Application for a licence to construct one BWRX-300 reactor at the Darlington New Nuclear Project Site (DNNP)

Revised Intervenor Submission

OPG application for a license for Construction of a
BWRX300 within the exclusion zone of the operating
Darlington NGS.

A Canadian Nuclear Reactor Safety Engineer's Independent and Objective Review of the OPG Application to Construct BWRX-300 Reactors within Darlington Site

Figure 1 : Example of one of the 'Break Exclusion zones claimed by GE Hitachi.

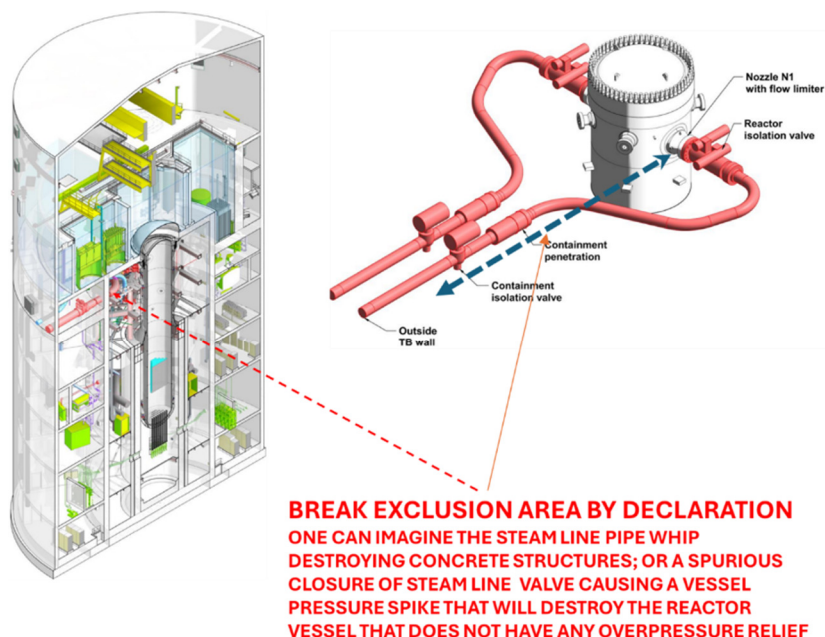
The bizarre vendor claims of eternal safety and piping/valve integrity in the so-called Break Exclusion Zones where failure of any pipe or valve is claimed to be incredible / inconsequential, is certainly not conservative or logical and its acceptance on face value is contrary to our country's interests. GE Hitachi claims that even fundamental hydro-dynamic reactions like a pipe whip cannot damage the appended isolation valves in a manner that creates a very undesirable system response. The reactor vendor decided to invoke perfection and eternal safety by referring to **a non-existent for ANY BWR, incredible large steam/feedwater pipe "leak before break" (LBB) crutch**, effectively eliminating consideration of a sudden large pipe break scenario. Is this sound engineering or just engineering euphoria? Or a total misrepresentation?

Remember - the application of LBB is limited to piping that is not likely to be susceptible to failure from various degradation mechanisms in service. That is not true for feedwater or steam pipes of the BWR. These pipes degrade by an unavoidable flow accelerated corrosion. *From the NRC experience, a significant portion of any LBB review involves the evaluation of the susceptibility of the candidate piping to various degradation mechanisms. The LBB approach cannot be applied to piping that can fail in service from such effects as water hammer, creep, erosion or corrosion excessive fatigue...Currently, approximately two-thirds of the PWRs in the U.S. have approval for the application of the LBB concept in the primary coolant loop.... The application of the LBB concept has not been approved yet for any boiling water reactor (BWR) (verbatim taken from reference 1 – a good summary; many more references available on LBB].* As a nation we must develop our own understanding, but the data on flow accelerated corrosion and failures speak for themselves.

Figure 3 : In a rush to be small, some very sound safety elements from ESBWR were dropped. No real connection remains between the two.

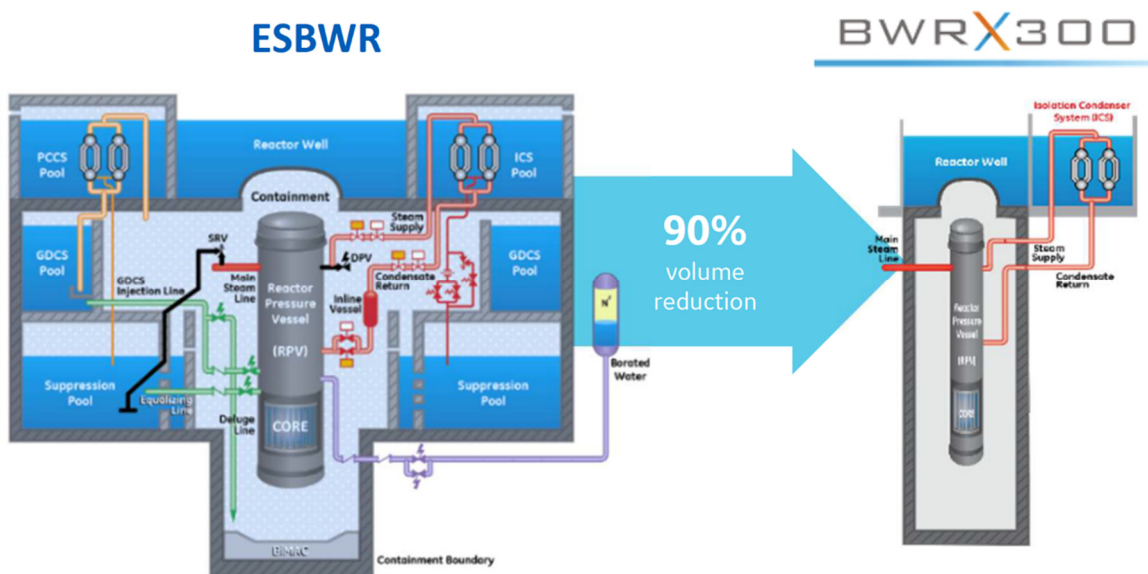
Safety systems have been inexplicably removed from BWRX that were intrinsic in its claimed predecessor, the 2011 US NRC approved ESBWR whose license was withdrawn in 2014 by NRC/GE Hitachi agreement after Fukushima. The deletion of most fundamental nuclear power reactor safety features allows GE Hitachi to achieve its celebrated 90% 'reduction' in volume in going from ESBWR to BWRX, making any claim of the BWRX being a derivative or offshoot of the ESBWR baseless. In my opinion, however, such safety system deletions cause at least a 1000 fold increase in risk to all stake-holders, including the innocent Canadian public, which has no option but to put its trust in the industry friendly regulator CNSC. Looks like the proponents have spent more energy on marketing than on engineering a safe reactor that we all in the reactor safety community can celebrate.

Even with gross simplifications and removal of critical safety systems, misrepresentations about the BWRX abound. More once more design information is made available. But for example, even the pressure boundary and the extent of the containment structure is likely misrepresented in the above figure. That is the least of the misrepresentations I have encountered. A common claim of the BWRX-300 reactor being a ‘natural circulation reactor’ is also misleading as the old BWR core recirculating pumps are out but recirculating flow around the core is powered by huge feedwater pumps and similarly pushed in a PWR boiler without they being ‘in natural circulation’.

Figure 4 : Isolation valve attached to the pressure vessel.

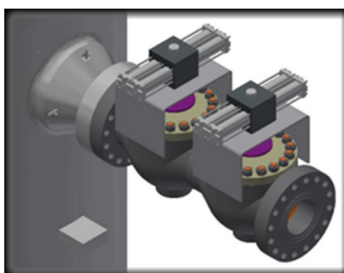
Here is a GE Hitachi artist's rendition of a BWRX pipe isolation valve that is, according to GE Hitachi considered 'integral' to the BWRX pressure vessel and hence 'fail proof'. That begs the question - how can a bolted-on valve be considered integral to the body of the huge pressure vessel it is attached to? Besides, failure mechanisms for such a valve work independently, consistently and with likely immediate, fast acting and disastrous consequences that cannot await any slow acting 'passive' mitigation system like the only available defence in this reactor, their fabled isolation condenser.

The argument about the Containment isolation valves being 'integral to the reactor pressure vessel' and hence infallible, ignores so many modes of valve failure. The risk of failure is especially acute, but not limited to a valve that is constantly in the path of hot, high velocity fluids – while subjected to structural stresses, corrosive environments, undergoing erosion and yet never capable of being subjected to any interior inspections. Valve failure data are abundant. It is not commonly known, perhaps not even to the Commissioners, that reactor pressure boundary isolation valves (LRVs) in CANDU reactors have caused at least 4 LOCAs due to inadvertent actuation. The Commissioners can ask the staff if they know about that fact.
